The Beach – Apollo Bay

Development Plan Summary

17 January 2018

Beveridge Williams Melbourne Office 1 Glenferrie Road Malvern Vic 3144 PO Box 61 Malvern Vic 3144 Tel: (03) 9524 8888 beveridgewilliams.com.au	Title	Development Plan Summary
	Author	Leanne Nickels
	Checked	Mark Fleming
	Project Manager	Bernard Stewart
	Synopsis	Brief report discussing the revised development plan

APPENDIX C. Potential Future Streetscape Render

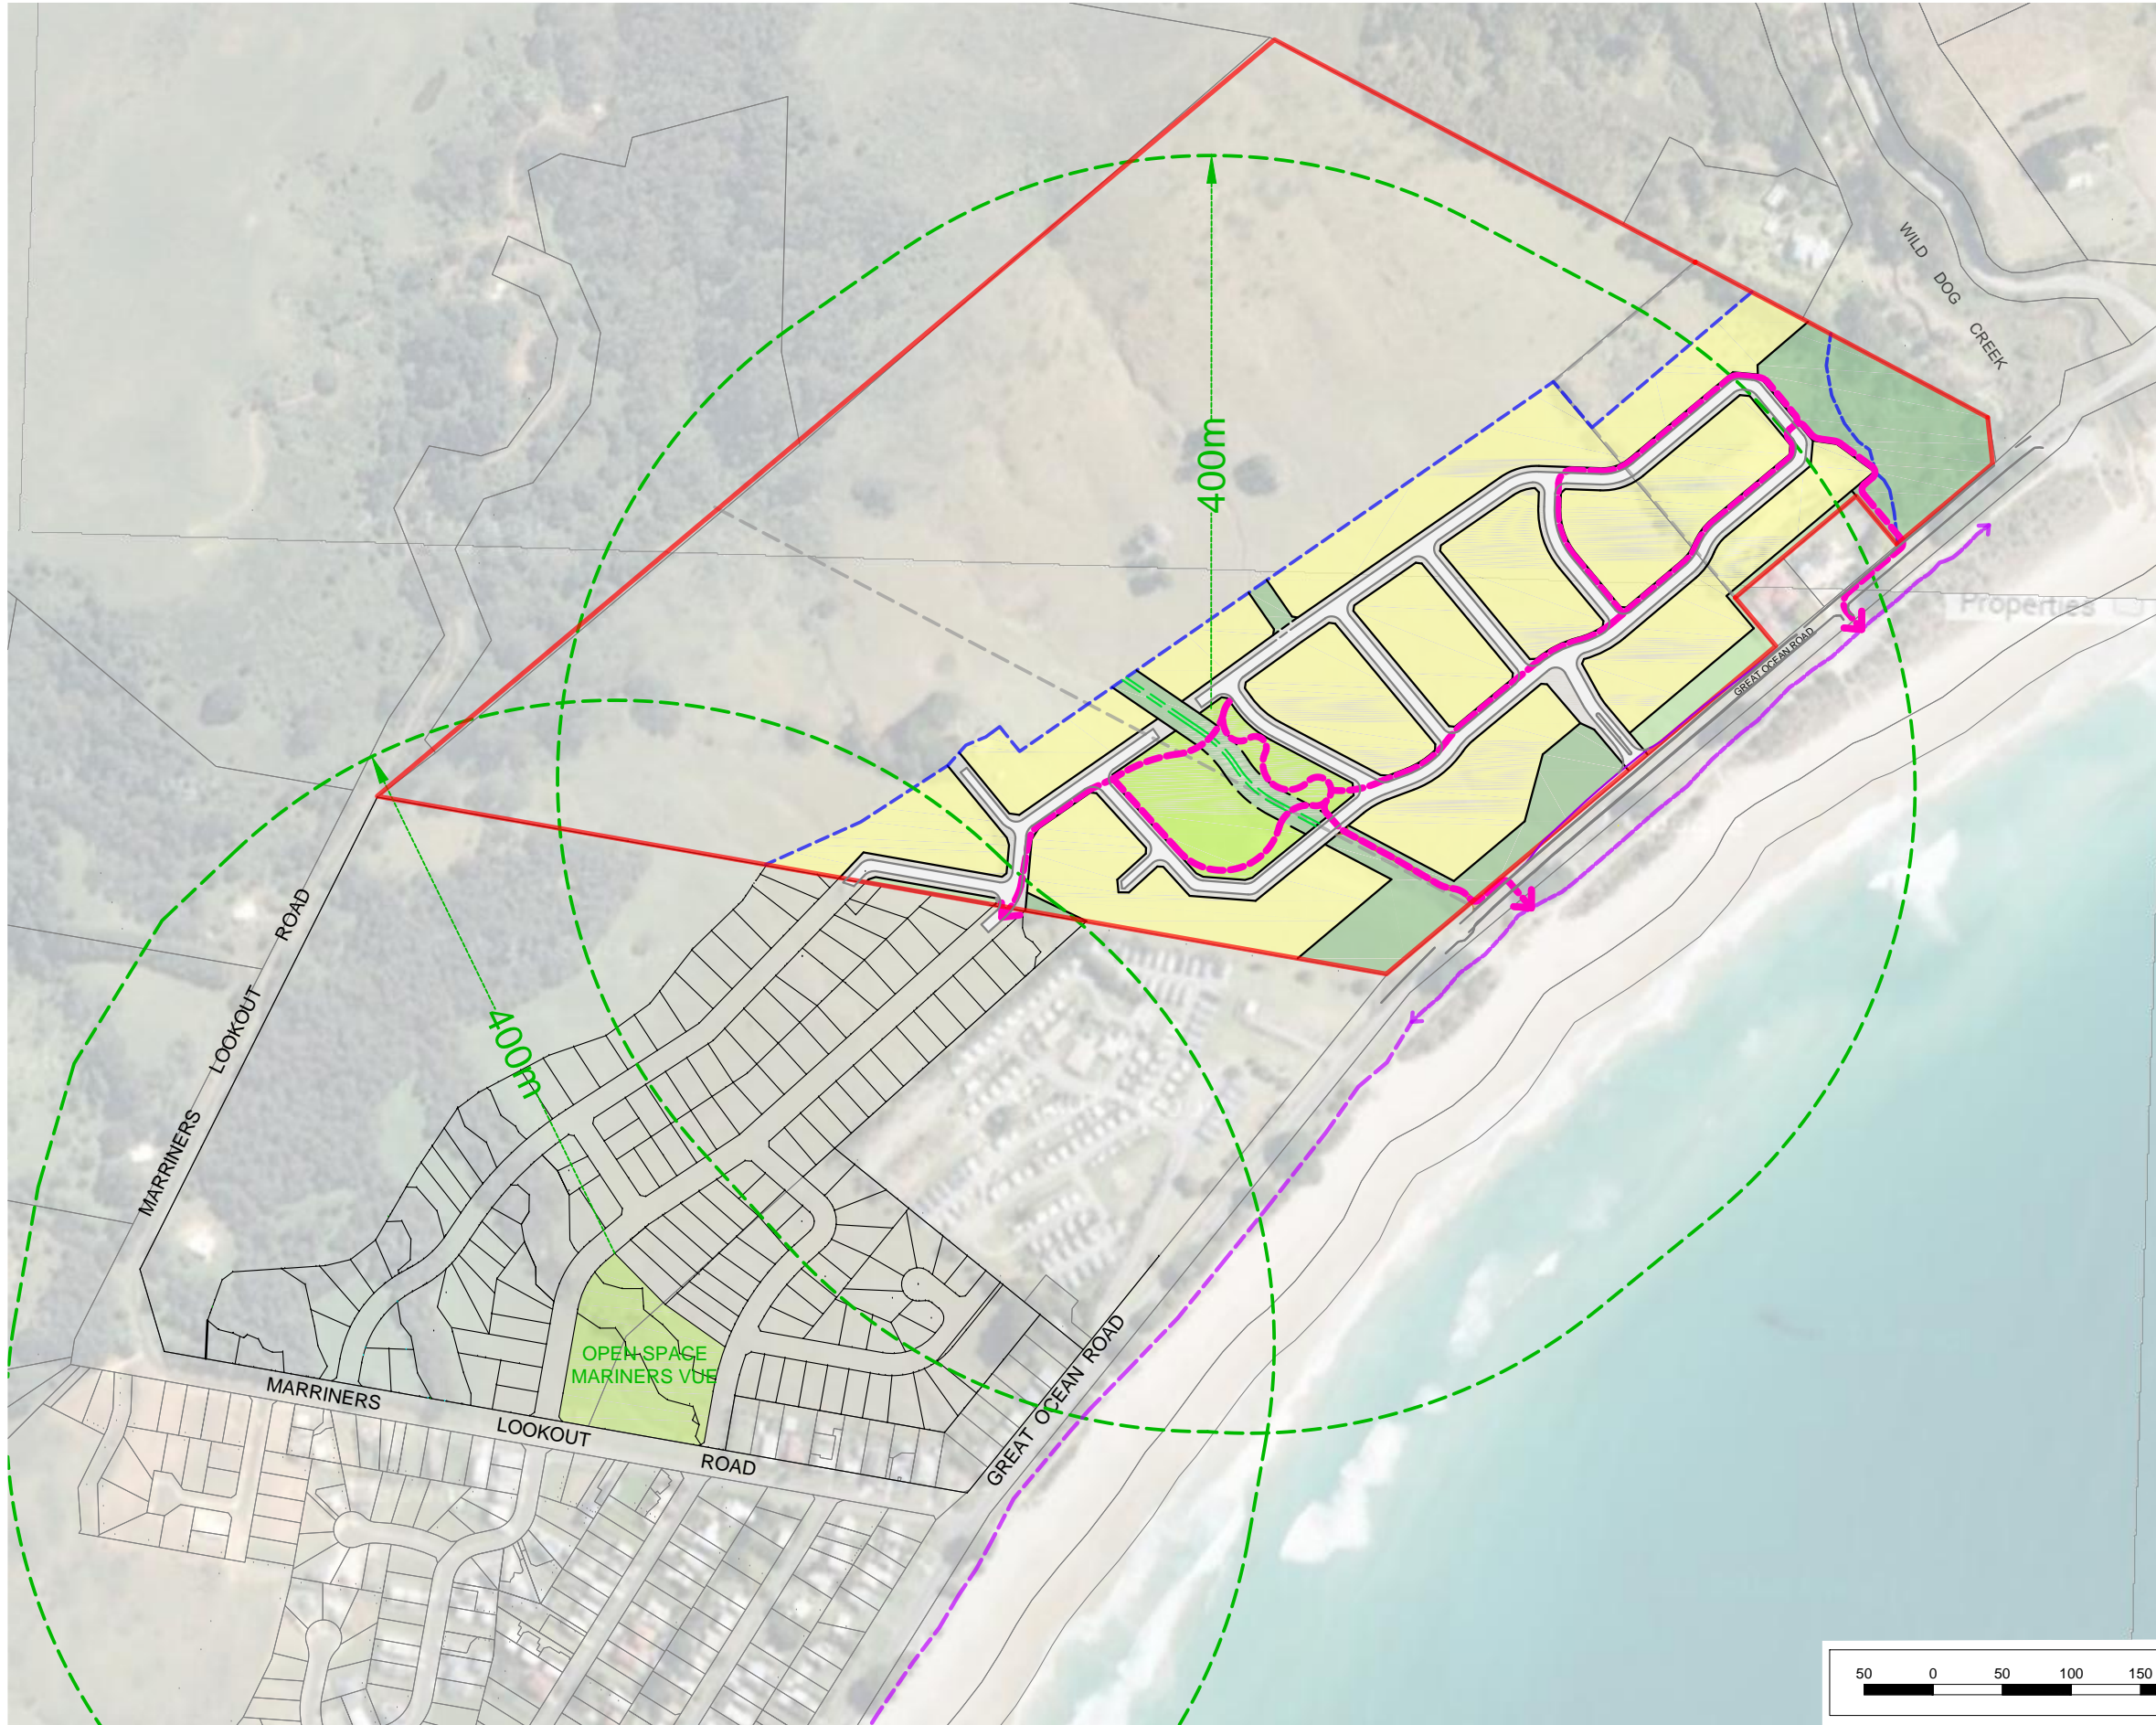
Council pointed out that the oblique view, travelling into Apollo Bay along the Great Ocean Road has also had high importance to locals and Councillors in the area. In response, the attached “Potential Future Streetscape” render has been produced, showing that the views will not be adversely impacted. A number of taller species is intended to be interspersed with the vegetation in the landscape buffer, providing further screening of houses and enhancing the aesthetic appeal of the estate.

APPENDIX E. Draft Neighbourhood Park Concept Plan

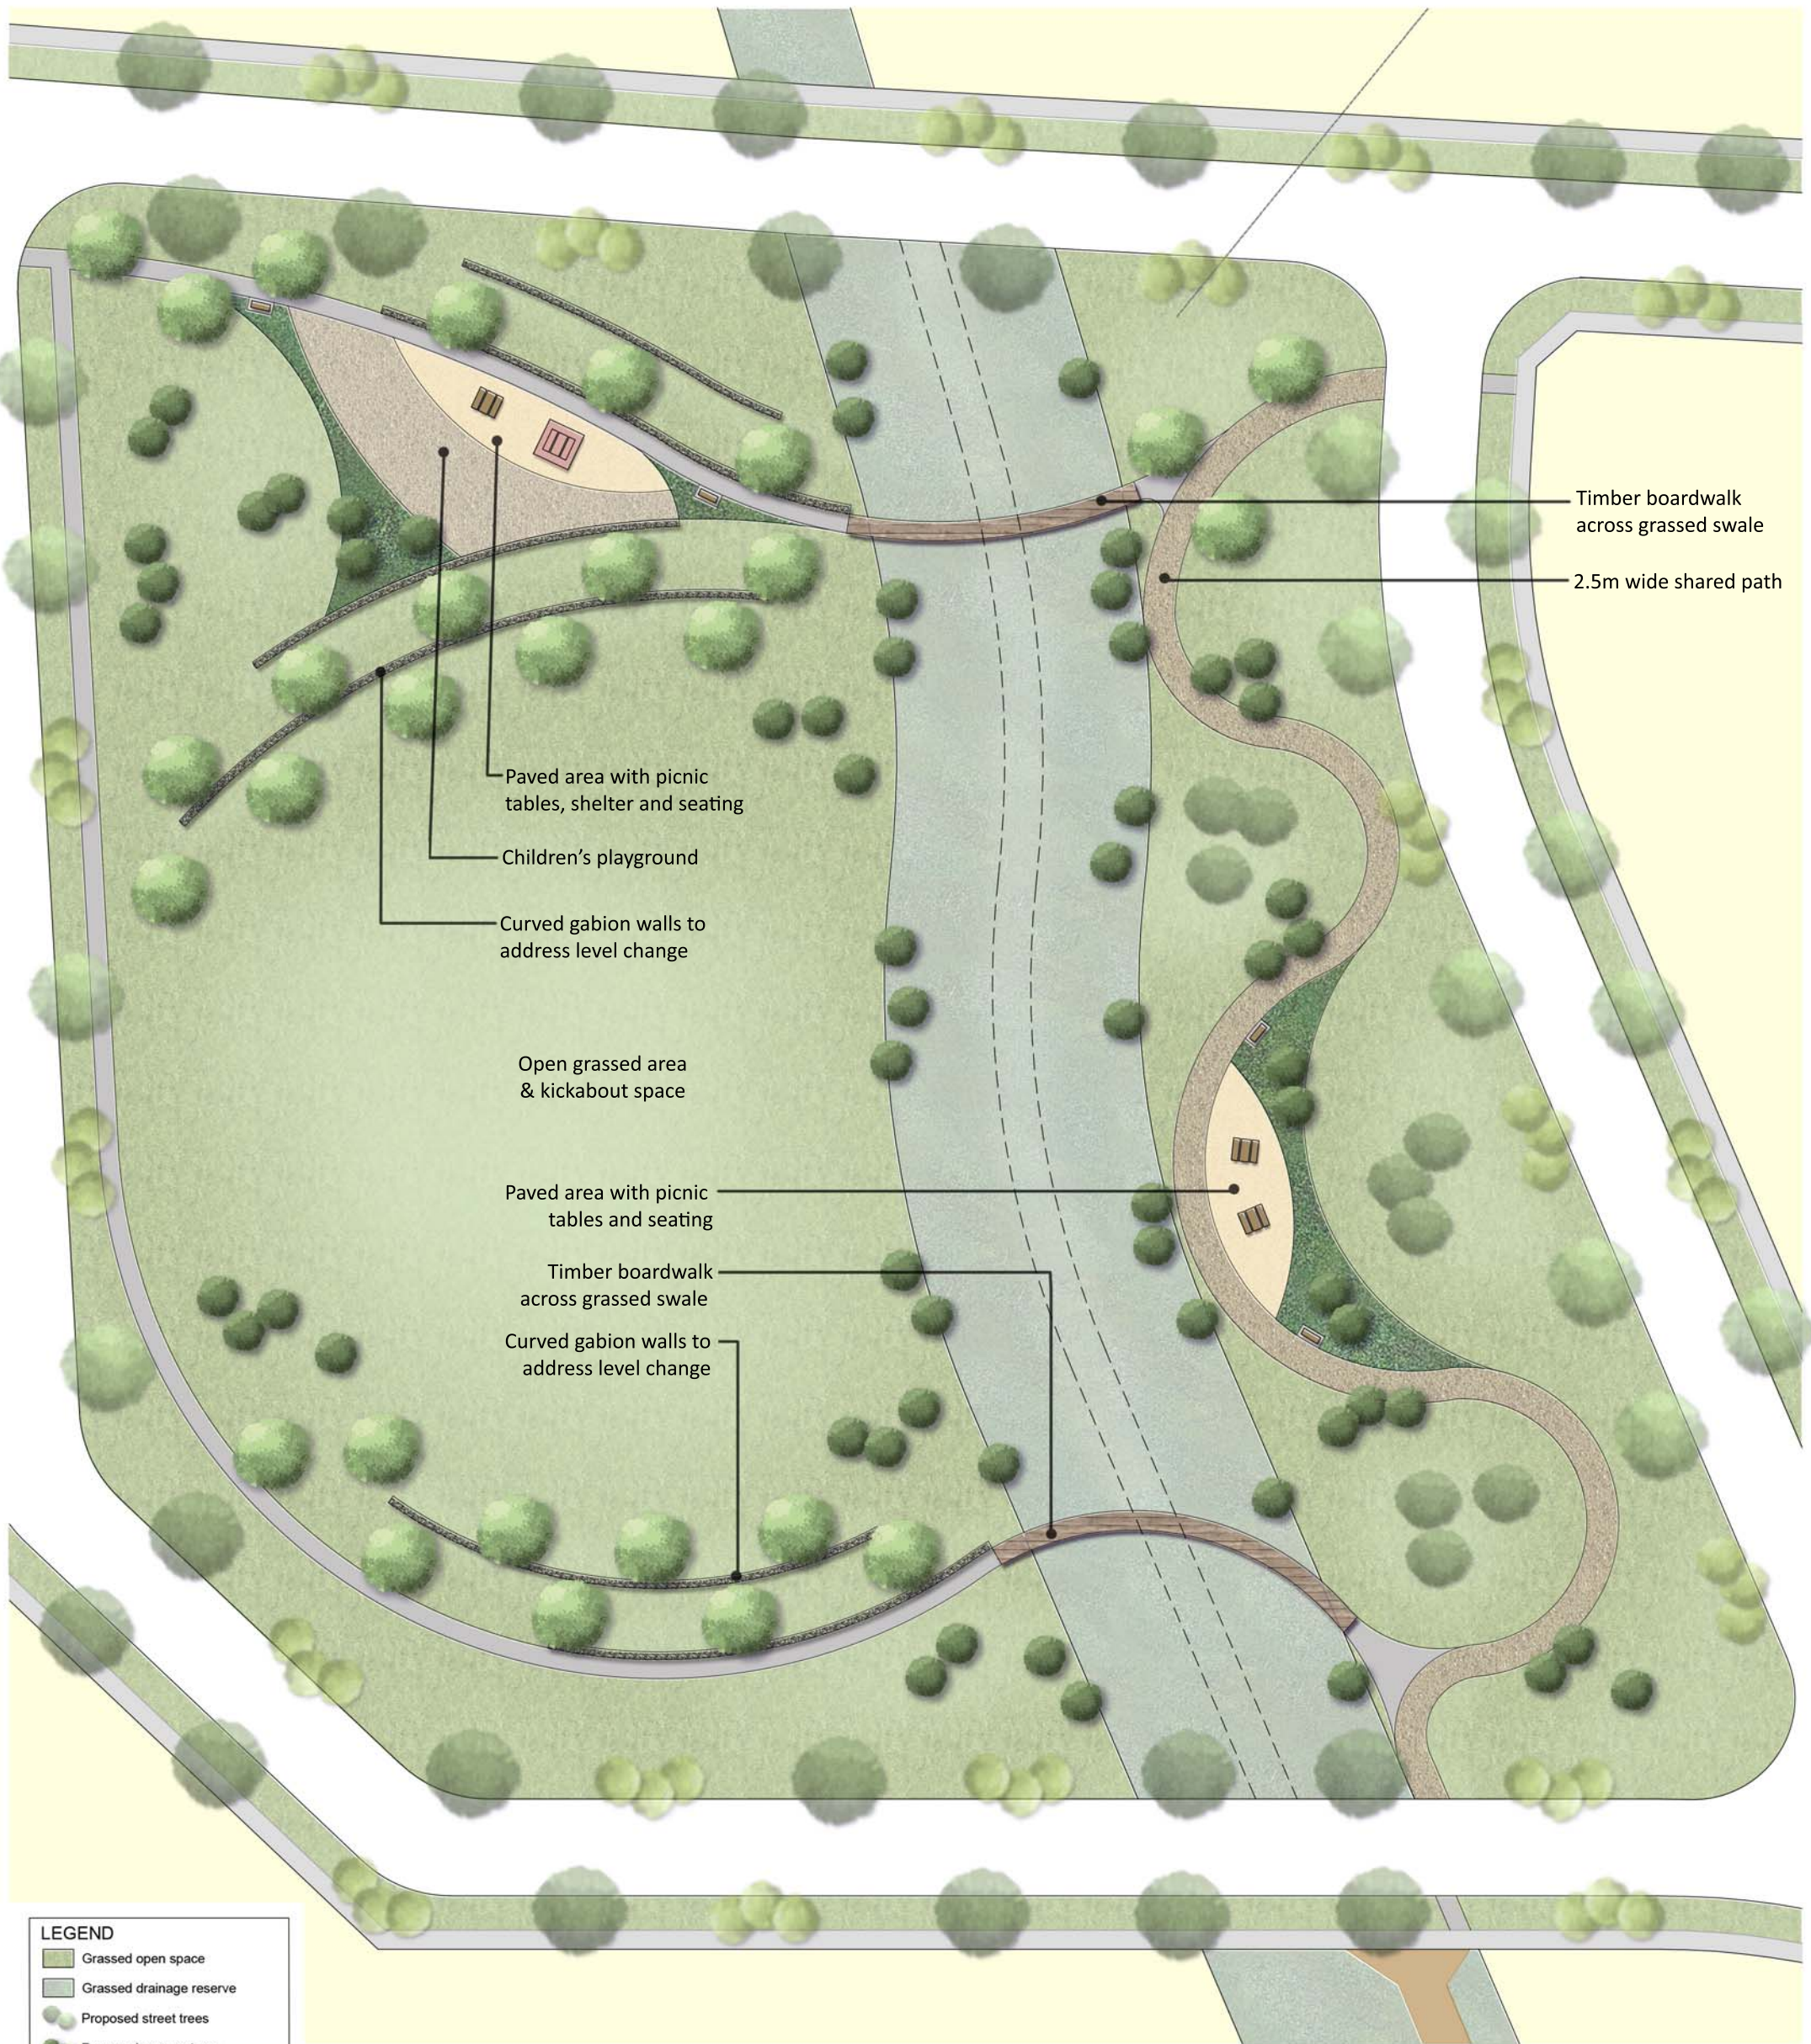
A draft concept plan has been provided (Appendix E), which demonstrates that the proposed site can comply with Table 7.1 of the Colac Otway Public Open Space Strategy, for a Neighbourhood Parkland.

The plan provides for a DDA compliant walking path, picnic facilities, and tree plantings. Additionally, a children's playground is proposed, in order to meet the requirements of DPO5.

Boardwalk crossings are proposed, to provide for pedestrian access across the drainage channel, while curved gabion walls will allow the slope to be softened to provide for an informal play area.

The side walls of the channel are proposed to be provided at a 1:6 grade, to allow them to be grassed, and thus easily mown and maintained with the rest of the reserve.
